Re: Turkey Point Units 3 and 4  
Docket Nos. 50-250 and 50-251  
Supplement to License Amendment Request 196 (ADAMS Accession No. ML092050112) – Revised Summary of Turkey Point Sump pH Calculation Inputs, Assumptions, Methodology, and Results

LICENSE AMENDMENT REQUEST 196  
REVISED SUMMARY OF SUMP pH CALCULATION INPUTS,  
ASSUMPTIONS, METHODOLOGY AND RESULTS

NAI-1396-046, Rev. 2, Turkey Point Units 3 & 4 Post-LOCA Sump pH Report

Figure 3: Case 1 sump pH profile

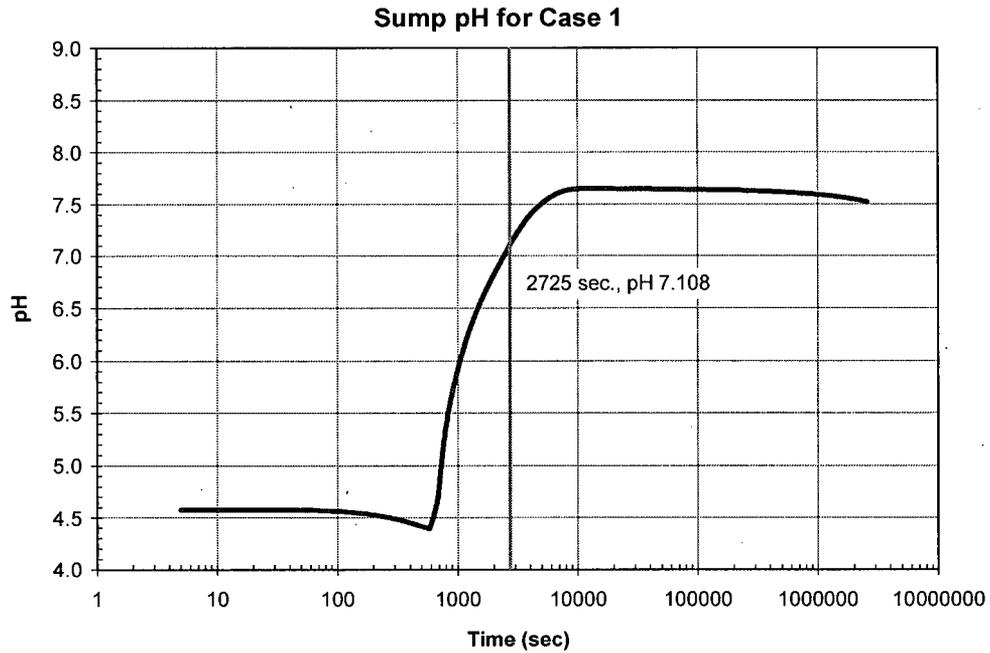
**NRC Questions 1 and 2:**

- 1. Provide time dependant values of strong acid concentrations in the sump for a period of 30 days after a loss of coolant accident (LOCA).***
- 2. Describe the analysis methodology used, including assumptions and inputs, to determine the pH in the sump water during a period of 30 days post-LOCA. Include detailed calculations of time dependant pH values in the sump during a 30-day period post-LOCA to demonstrate that the pH remains greater than 7 throughout this time period.***

The time-dependent pH profile for Cases 1 and 2 are shown in Figure 3 and Figure 4, respectively. The corresponding minimum long-term pH varies between 7.366 and 7.522 for these cases. Each of these figures shows the sump pH initially decreasing due to hydrochloric and nitric acid generation. The pH increases quickly once the water level reaches the bottom of the baskets and begins dissolving the borax. The peak sump pH is reached once all of the borax is dissolved and then begins declining due to continued acid generation. Table 2 summarizes the inputs and results for these cases.
